## Access Compliance Report Public Rights-of-Way (Curb Ramps)

Intersection ID: 44487 Main Street: REAMES\_RD Cross Street: FINN\_HALL\_AV Location: N

ADA ID: BC875307DBD3 Ramp Type: Perp Initial Pass/Fail: Fail Overall Compliance: No Severity Score: 33.75

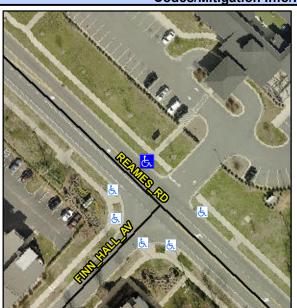
Not Found, R304.5.1, R304.5.3

Field Measure	ments/C	ompo	nent Compliance	
Compliance Description		Data	Compliance Description		Data
N/A	Ramp Length (in)	95.5	Yes	Ramp Slope (%)	8.1
No	Ramp Width (in)	45.5	No	Ramp XSlope (%)	9.1
N/A	Flare Type LT	N/A	N/A	Flare Type RT	N/A
N/A	Flare Slope LT (%)	N/A	N/A	Flare Slope RT (%)	N/A
N/A	Flare Traversable LT?	N/A	N/A	Flare Traversable RT?	N/A
N/A	Landing Length (in)	N/A	N/A	DWS Provided?	N/A
N/A	Landing Width (in)	N/A	N/A	DWS Contrast?	N/A
N/A	Landing Slope (%)	N/A	N/A	DWS Length (in)	N/A
N/A	Landing X Slope (%)	N/A	N/A	DWS Full Width?	N/A
N/A	Landing Curb? (Y/N)	N/A	N/A	DWS Offset (in)	N/A
N/A	Shared Landing?	N/A			
N/A	Gutter Ponding?	N/A	N/A	Gutter Slope (%)	N/A
N/A	Gutter Lip Ht (in)	N/A	N/A	Gutter X Slope (%)	N/A
N/A	Painted X Walk1?	No	N/A	Painted X Walk2?	N/A
	X Walk 1 Direction	To W		X Walk 2 Direction	N/A
N/A	X Walk 1 Width (in)	N/A	N/A	X Walk 2 Width (in)	N/A
	X Walk 1 Slope (%)	3.2		X Walk 2 Slope (%)	N/A

Remove & Replace Entire Ramp.
